AGENDA ITEM EXECUTIVE SUMMARY		Agenda Item Number: 4b
	Title:	Presentation of a Concept Plan for Milestone Row 2.	
	Presenter:	Ellen Johnson	
Meeting: Planning & Development Committee		Date: August 8, 2022	
Proposed Cost:		Budgeted Amount:	Not Budgeted: <input type="checkbox"/>
<u>Background</u>			
<p>A Concept Plan has been filed by J&B Builders, Inc. proposing to construct a mixed-use building on the remaining vacant lot in the Brownstone PUD, located at the NE corner of S 1st and Prairie Streets. The proposal includes:</p>			
<ul style="list-style-type: none"> • 50 ft., four-story building fronting 1st St. <ul style="list-style-type: none"> ○ Floor 1 – commercial space & parking ○ Floors 2-4 – up to 20 residential condo units • 44 interior parking spaces for building residents, accessed from Cobblestone Dr. • 15 on-street parking spaces along 1st St. 			
<p>The building planned for the subject property under a 2005 PUD Amendment was nearly identical to the existing Milestone Row building to the north. The proposed building is similar in configuration, massing and land use, but differs in several ways as outlined in the Staff Report. Should the project move forward, approval of a

OUTLINE OF
MILBSTONE 1

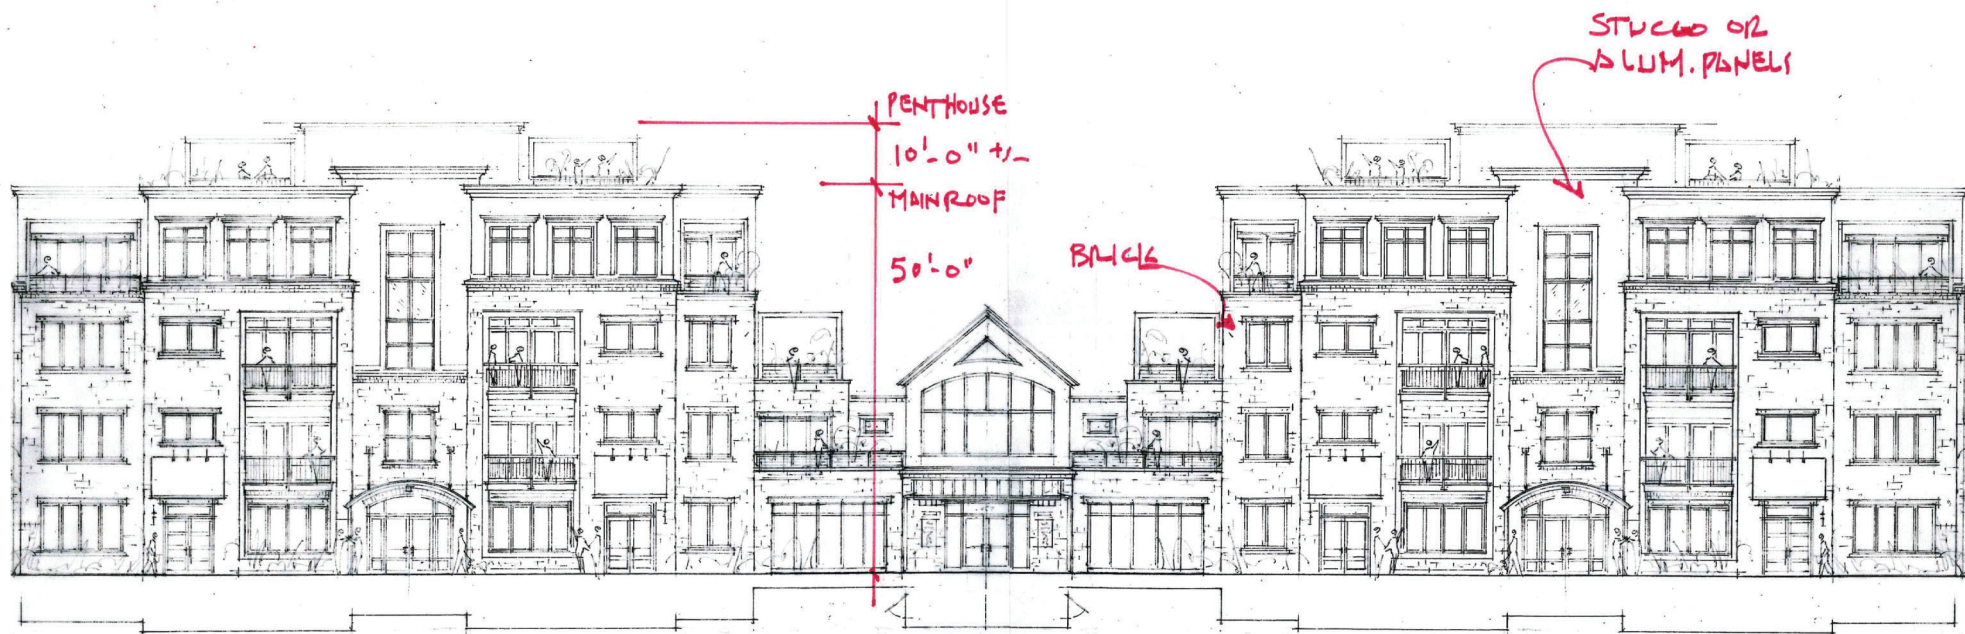
- Building mass split by a two-story central section instead of a one-story breezeway (see exhibit showing proposed building overlaid with the Milestone Row building outline).
- Larger building footprint (22,705 sf vs. 16,000 sf).
- Parking for residents on the ground-level instead of underground.
- Less Commercial space (limited to western portion of first floor instead of the entire first floor.)
- Fewer parking spaces behind the building along Limestone Dr. (5 vs. 18 parking spaces planned, due to larger building footprint)
- Curb cut for resident parking access off Cobblestone Dr. (north end) instead of Limestone Dr. (rear/east side).
- More modern architectural style.

- ✓ The proposed building has a larger footprint than the approved building (22,702 sf proposed vs. approx. 15,000 sf planned). However, while the approved building was four full stories, the central portion of the proposed building is only two stories and contains parking for a majority of the first floor. This results in an overall gross floor area that is only about 2,500 sf larger than the approved building.
